## Addendum No. 1

Project Name: SCC – P. Dan Hull Building Roof Replacement  
Project Number: H59-6273 - PD

WMBE Project Number: 2023-47

OVERALL EXISTING  
ROOF PLAN

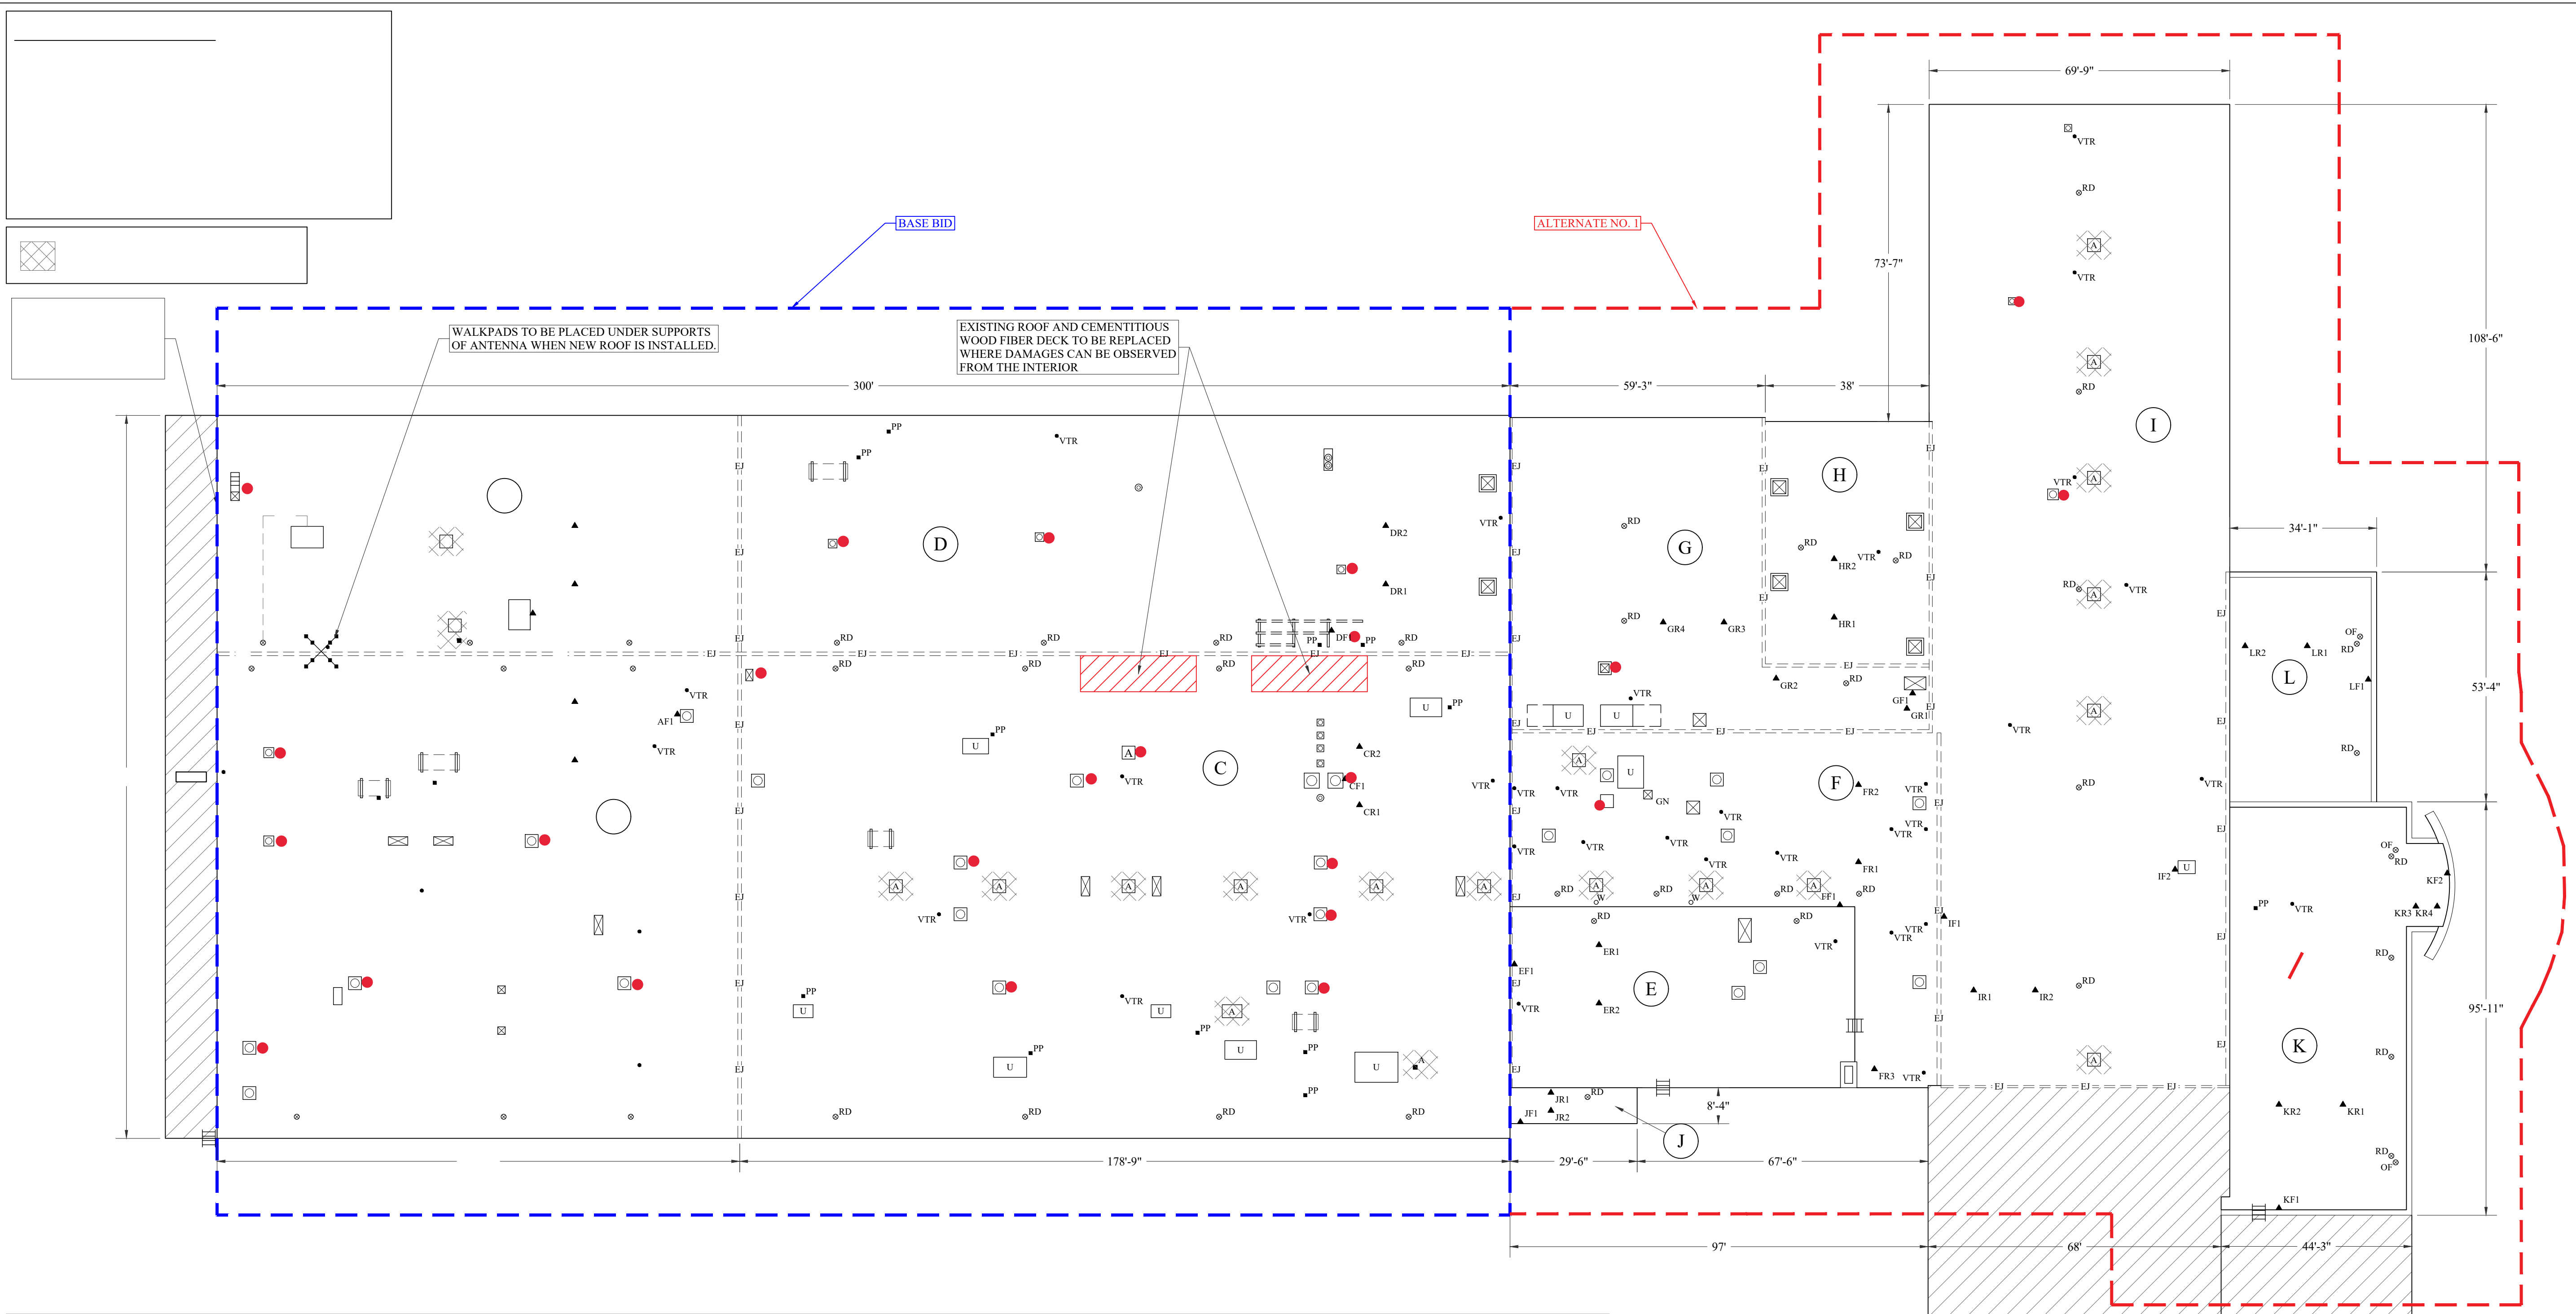
1. Changes to Bidding Requirements:
  - a. None.
2. Changes to Specifications:
  - a. None
3. Changes to Drawings:
  - a. Additional Drawing sheet provided in addendum for additional mechanical units and associated penetrations to be removed.

3. Question: How many units are abandoned to be removed?

Answer: In addition to the areas hatched with the cross hatch to be removed on the drawing plans there are approximately a total of (24) pieces / ventilators that are additional items to be removed.

(21) exhaust fans to remove. (2) HVAC units. One is a green colored "Swamp Cooler" we call it over the Kitchen. The other is the very old, abandoned HVAC unit sitting on the rusted steel above E46 HVAC lab. (1) Roof cap covered with sheet metal above E46 HVAC lab sink.

Plan is attached for reference marked with a red dot.

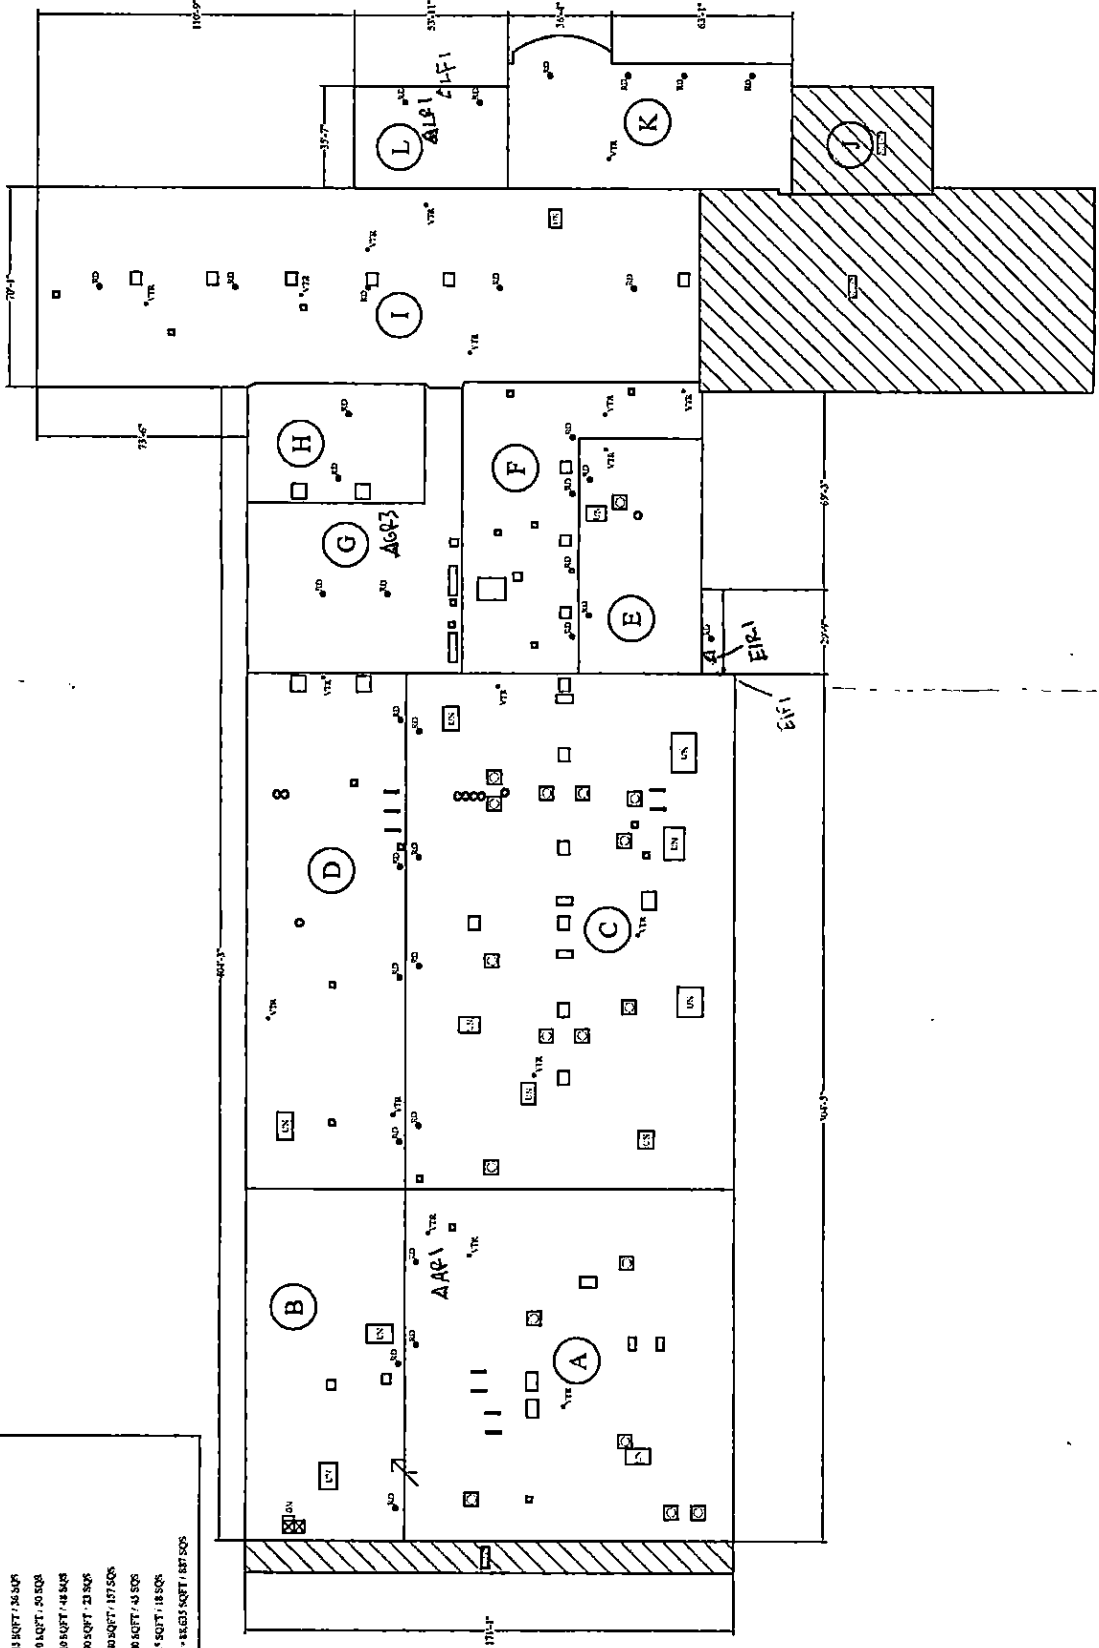
4. Question: Are there specific locations expected to have existing wet insulation to be removed and replaced.

Answer: Plan is attached with areas in red where test cuts will be completed prior to removal using the unit price line item.

RED AREAS ARE ANTICIPATED AREAS OF EXISTING WET ROOF INSULATION THAT WILL BE REMOVED AND REPLACED WITH NEW USING THE UNIT PRICE. TEST CUTS SHALL BE COMPLETED TO CONFIRM.
